ZONING CHANGE REVIEW SHEET

CASE: C14-2010-0087 (The Domain Rezoning-Simon) **P.C. DATE:** August 10, 2010
August 24, 2010

SUBJECT: C14-2010-0087 (Simon)

Shared Lane Marking

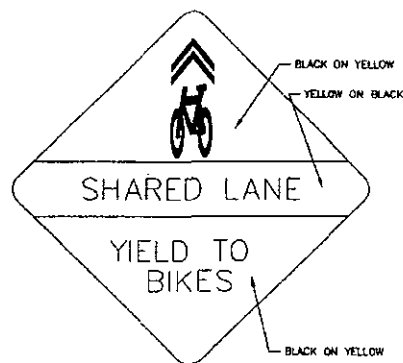
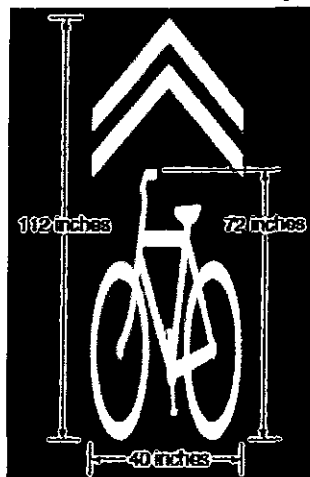
Additionally, the Bicycle Program recommends the installation of shared lane markings (sharrows) as depicted below along the following roadways:

- Esperanza Crossing from Oaks Terrace to Domain Dr
- Domain Dr. from Esperanza Crossing to Kramer Ln.
- Domain Dr. from Domain Blvd. to Esperanza Crossing, west side of the street only (*note: it's our assumption that Simon has control over the west side of the street only*).

The shared use markings (sharrows) shall be installed in compliance with the following standards:

- The shared land markings shall be placed with the tip of the chevron in the middle of the lane as measured from face of curb.
- A sharrow facility sign as shown below at a size no smaller than those signs currently installed on Kramer Ln. shall be placed at least 2 per block (one on each side of the street)
- Angled and head in parking prohibited on either side of roads with required sharrows.

C14-2010-0087 (Simon)

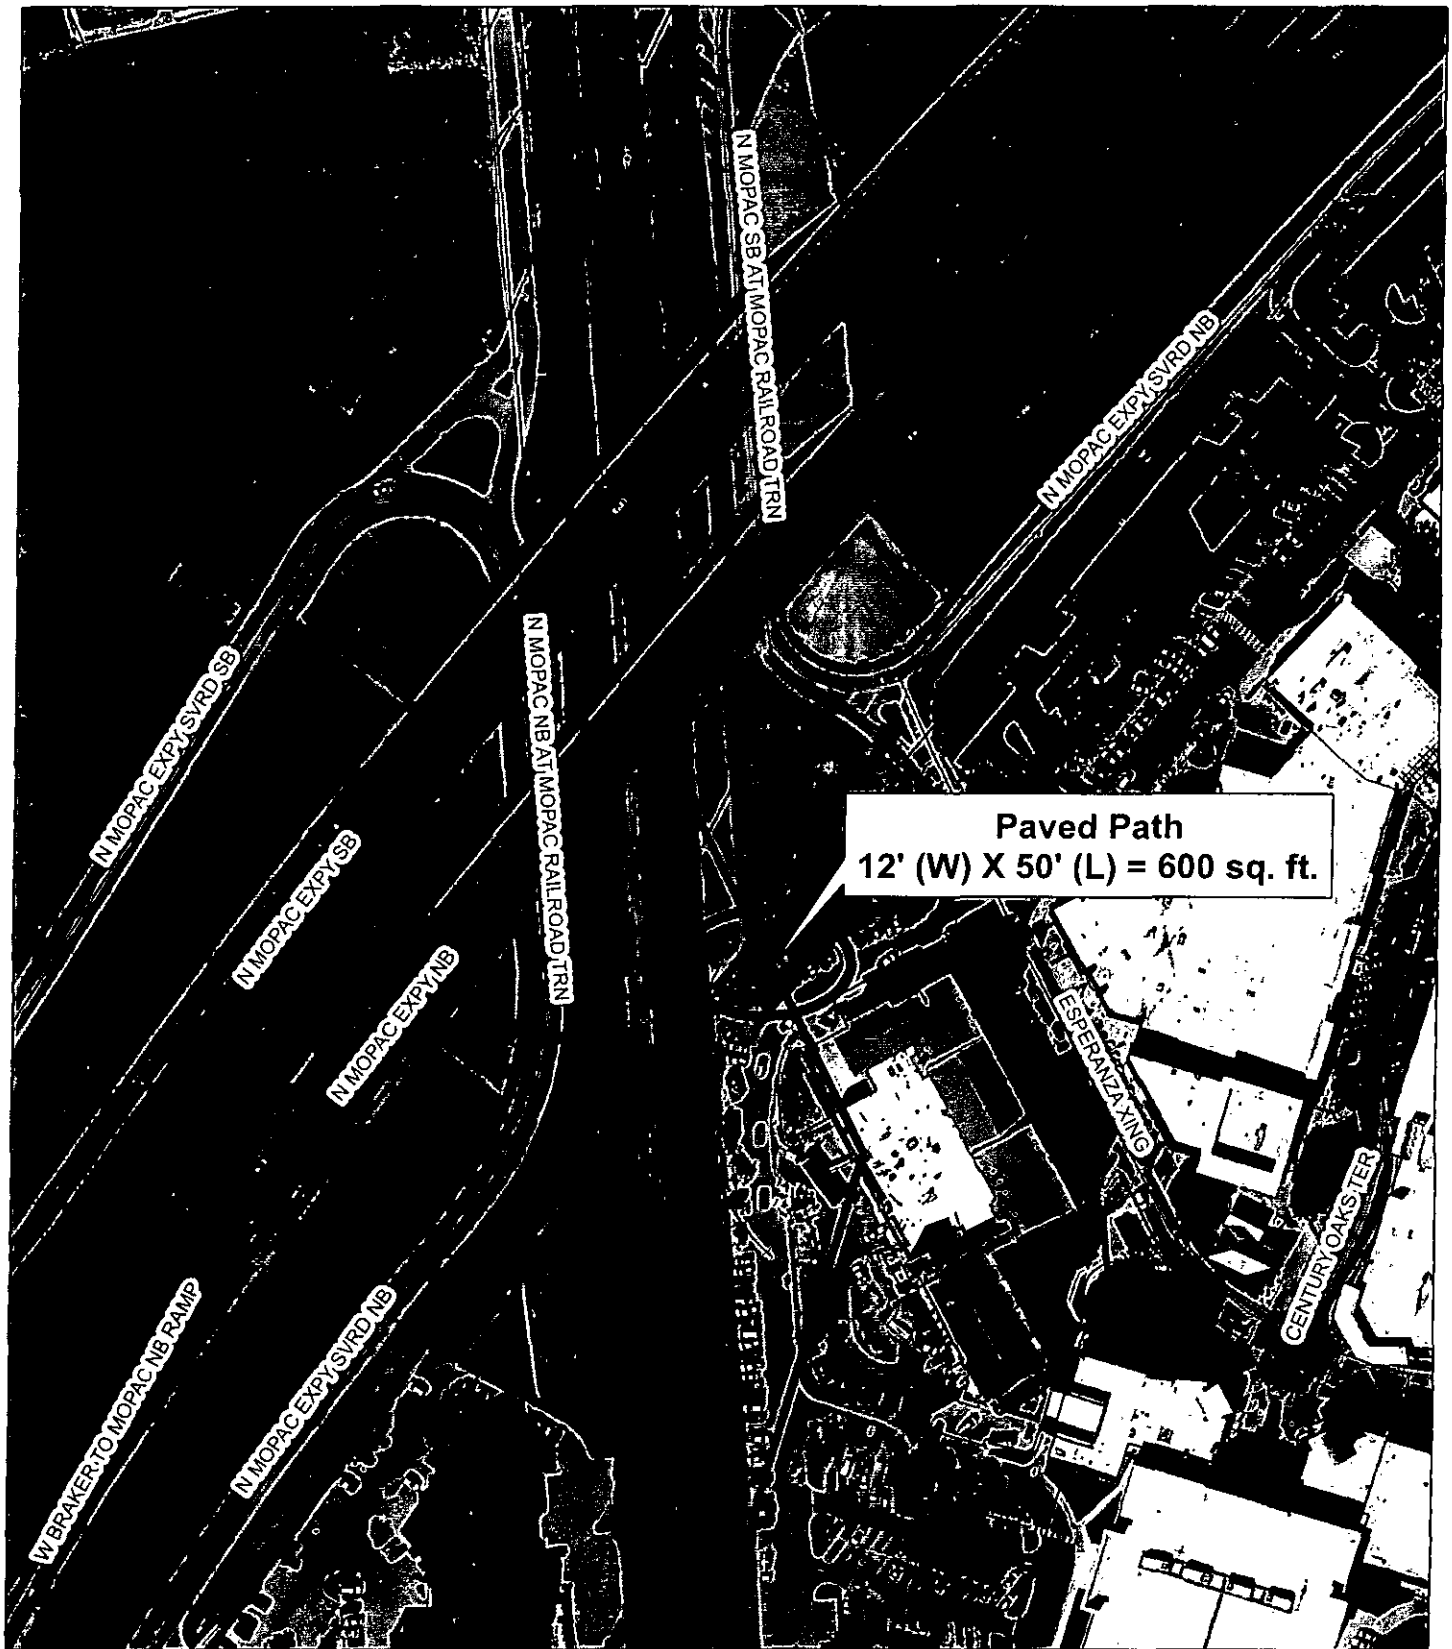
The City of Austin Bicycle Program recommends the applicant provide bicycle access and internal continuity for portion of Bicycle Route Segment #905.04 – Kramer LN from MOPAC EXPY N to Domain DR by providing and formalizing the pedestrian/bicycle entrance as identified on the attached bicycle network map including construction of a connecting minimum 12 foot paved path to the street with associated curb cut.

The formalized pedestrian/bicycle entrance, connecting path to the street, and shared lane markings (sharrows) shall be installed within one year of this agreement.
